Bass Coast Amendment C152 – Wonthaggi North East

Changes Report

May 2022

Figure 13 - PSP Boundary Amendment

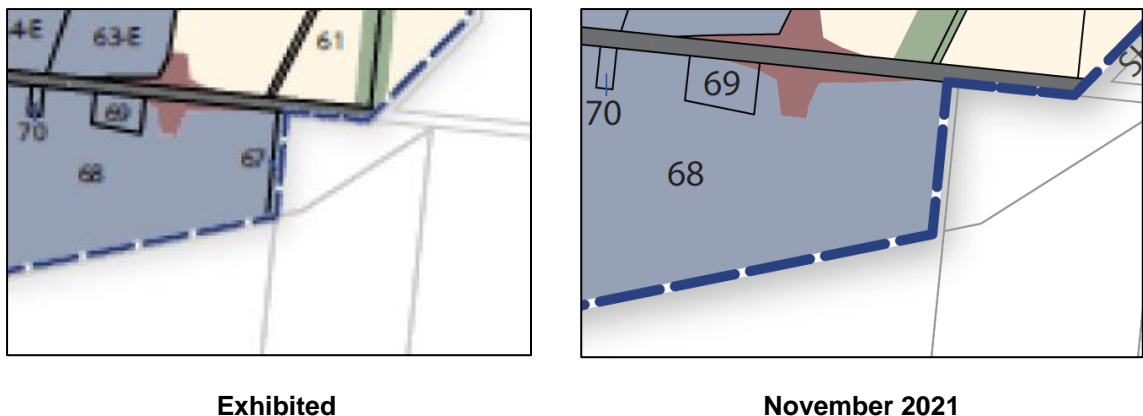
The PSP Boundary has been slightly amended to exclude PSP Property ID 67, which was mistakenly included within the boundary of the PSP. Property 67 was a small slither of land that formed part of a larger property to the south of the precinct (see Figure 13). In order to maintain continuity between the exhibited and November 2021 versions of the PSP and DCP, the numbering of all succeeding PSP properties have not changed. The property has been removed from the Land Use Budget table, and the boundary change is reflected in all PSP and DCP plans.

Figure 15 - Utility Plan Comparison

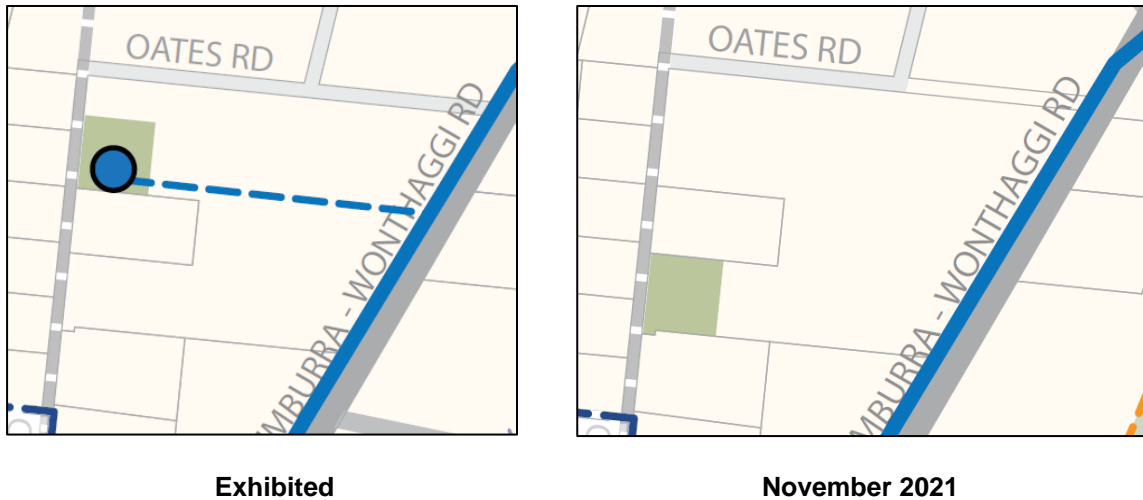
In response to the relocation of LP-05 as discussed in Section 3.0.7, South Gippsland Water were consulted regarding the location of a booster pump station shown in the same location as LP-05 in the exhibited version of the Utilities Plan. South Gippsland Water advised that the booster pump station was no longer needed in that location as they had plans to co-locate a booster pump station at their existing facility, and therefore recommended that the asset be removed from the PSP.

Plan 12 – Utilities has subsequently been amended in the November 2021 PSP to remove reference to the previously proposed booster pump station. This change is shown in Figure 15.

Figure 16 - Land Use Budget Plan Excerpt

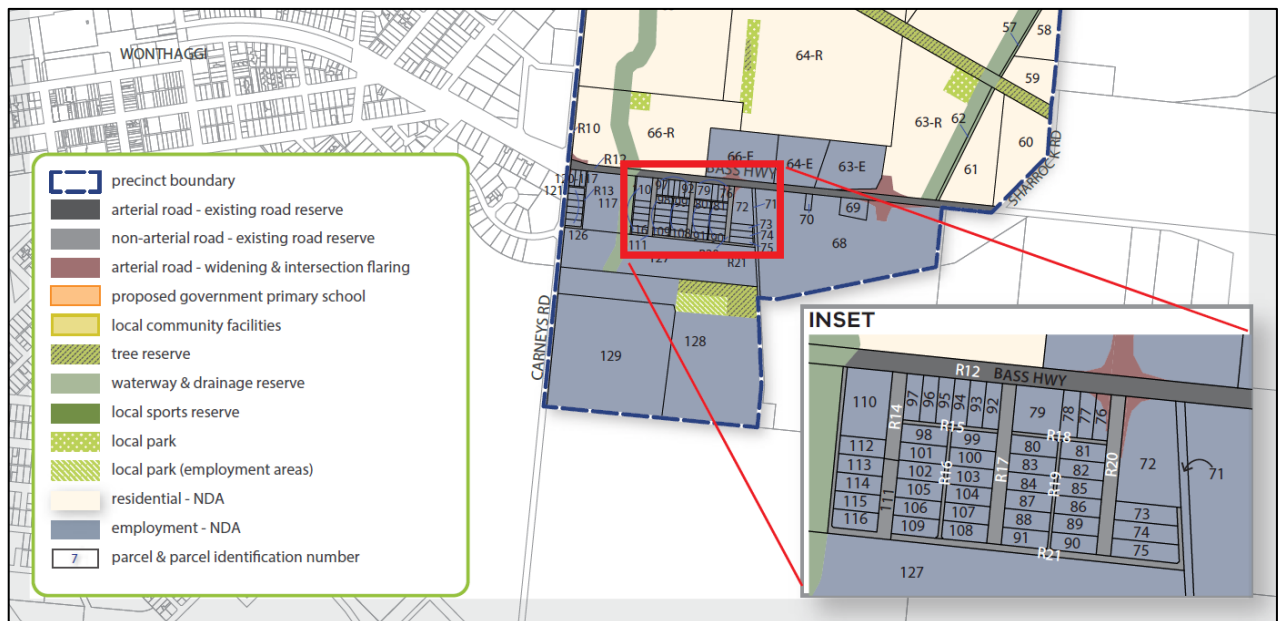
On the exhibited version of the Land Use Budget Plan, it was difficult to discern the PSP Property ID numbering of properties 73-109. As a result, an inset has been added to the plan which shows the numbering of the properties clearly. An excerpt of the revised plan in the November 2021 PSP is shown at Figure 16.

Figure 18 - Excerpt from Plan 20 Public Transport and Path Network

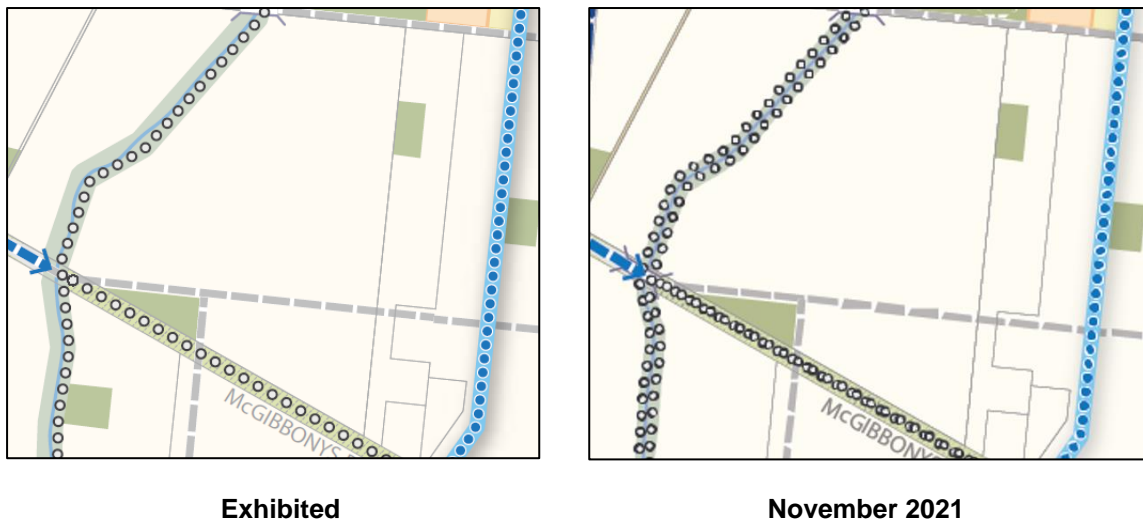
PSP Plan 10 was updated to clearly depict shared paths on both sides of the western north-south waterway. This change was made to ensure Plan 10 gave clear guidance on the expectation for provision of shared paths adjoining waterways that was consistent with Cross Section 14 and Requirement 46. An excerpt of the exhibited and current versions of Plan 10 showing this change is identified in Figure 18.

Figure 21 Proposed culvert crossings of the gas and water mains in 2019 Engeny Drainage Strategy

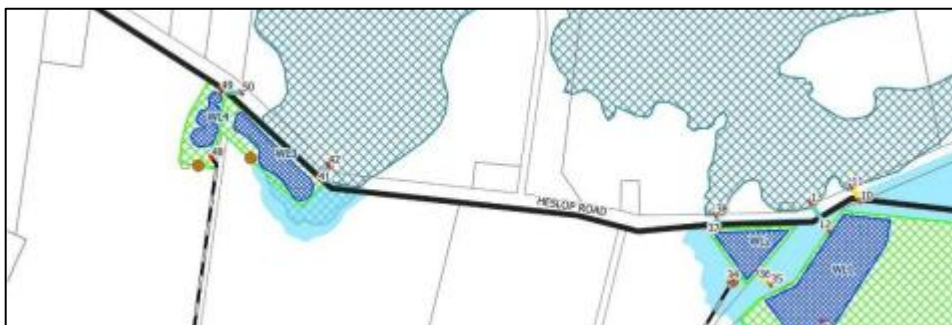
At the SMS workshop, it was agreed that VPA would be required to undertake more detailed investigations to develop the proposed culvert crossing of the gas main. It was agreed that service proving should be undertaken, as well as AHD datum surveys as required. Although consideration of the desalination pipeline did not form part of the scope of the SMS, the VPA deemed it appropriate to take a similar approach with the desalination pipeline (i.e. service proving and AHD datum survey).

The VPA commissioned Engeny to undertake the necessary service proving, surveys and consultation with utility providers to develop the culvert concept designs proposed in the 2019 strategy (refer Figure 19) to safely cross the gas and water mains.

Consequently, Engeny included the revised approach to crossing the gas and water mains in their revised 2021 Drainage Strategy. The 2021 Drainage Strategy refined the design approach to crossing the gas and water mains at WL-01 and WL-02. Alluvium adopted the proposed approach on the basis that it has been investigated adequately. Alluvium have included the relevant contingency costs in for CU-08, CU-10 and CU-12 (refer to table in Section 4.1).

Figure 22 - Excerpt of exhibited and current NVPP Plan 5

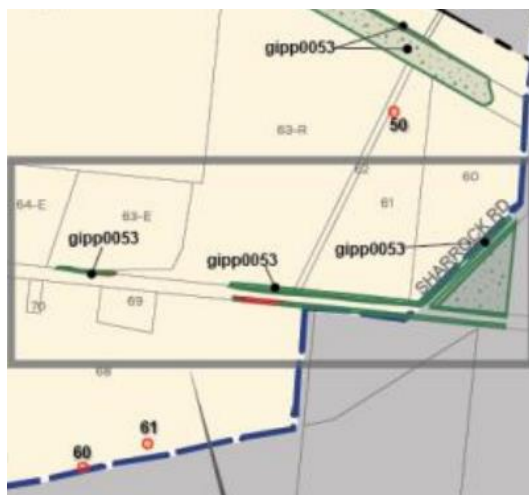
NVPP Plan 5 previously showed a small patch of trees within PSP Property ID 52. A review of aerial imagery indicated the trees identified in the Flora and Fauna Assessment conducted by Nature Advisory had since been cleared from the land. As such, the NVPP plan was updated to remove reference to the vegetation.

These changes are shown in Figure 20.

Figure 21 - Revised D-DPO Map

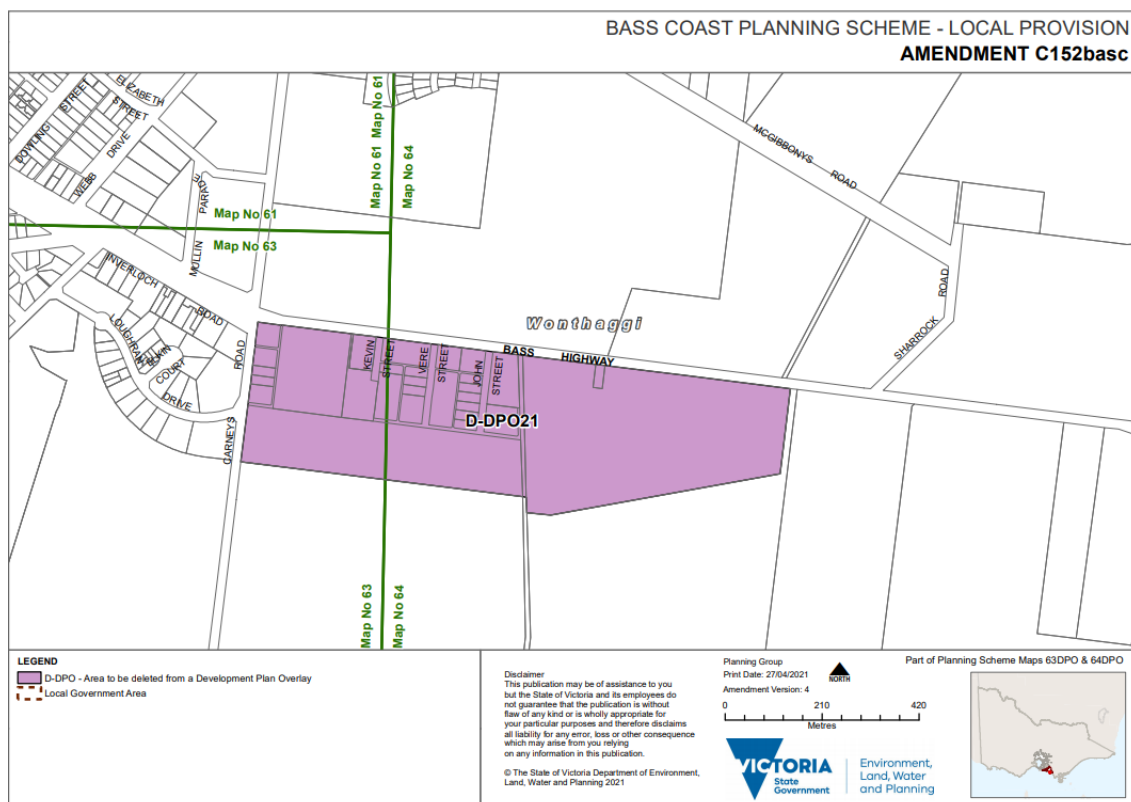
The properties to the south of the Bass Highway are being removed from the DPO but are to have the IPO2 applied to them as part of the draft amendment. Therefore, it was not the intention of the amendment to remove the DPO over any property without a similar provision replacing it.

An excerpt of the revised map is shown in Figure 21.

Figure 2322 - Revised EAO Map

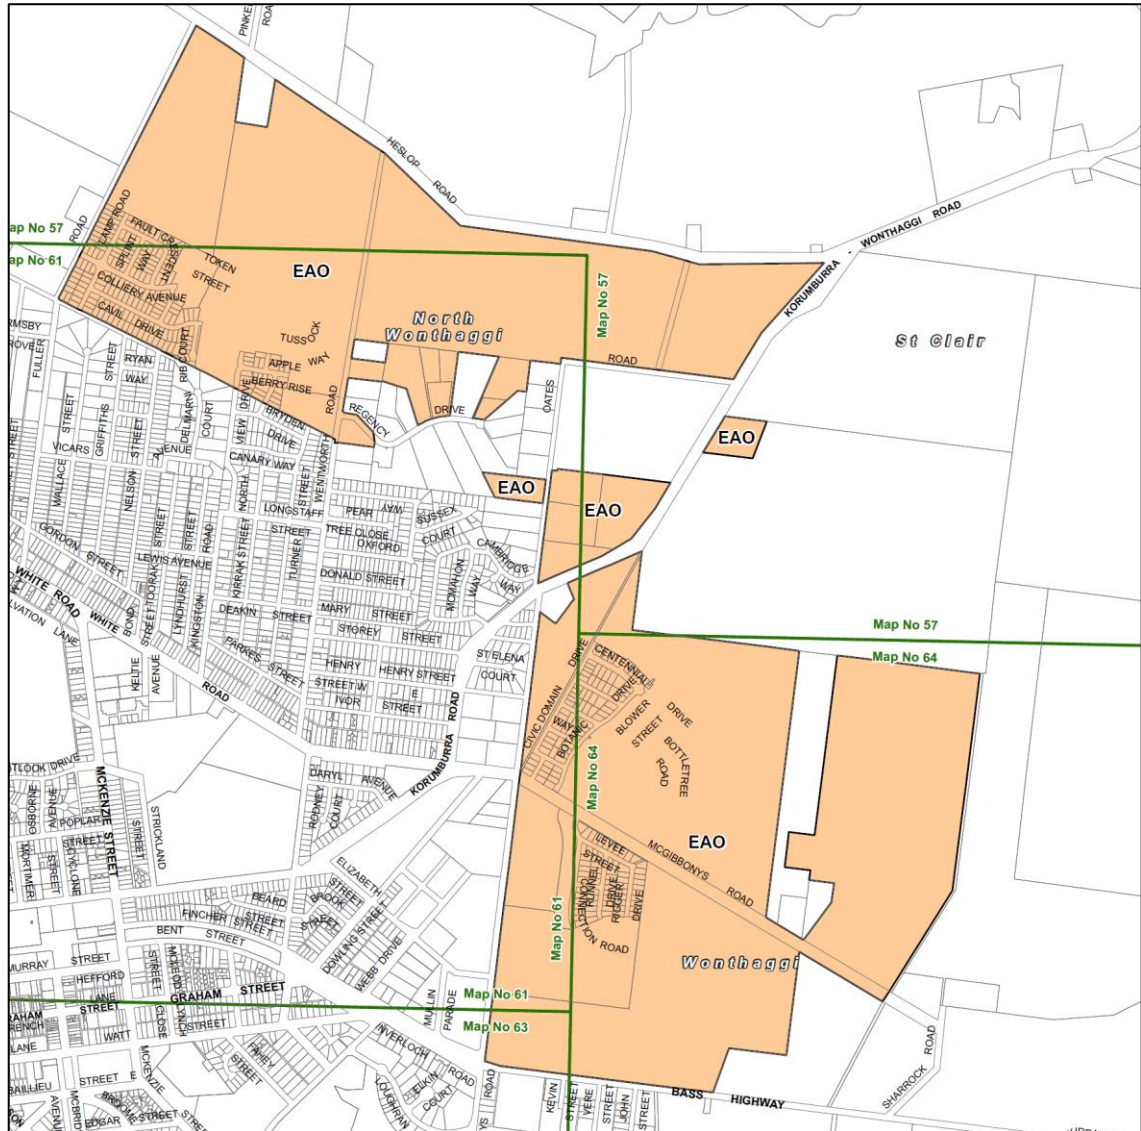
been retained, as a PSI remains the appropriate mechanism for potentially contaminated land intended for industrial uses, and the relevant IPO schedule will apply only to industrial properties.

An excerpt of the revised EAO map is provided In Figure 22. Clause 72.03 has also been updated to reflect the additional EAO Maps 63 and 64.
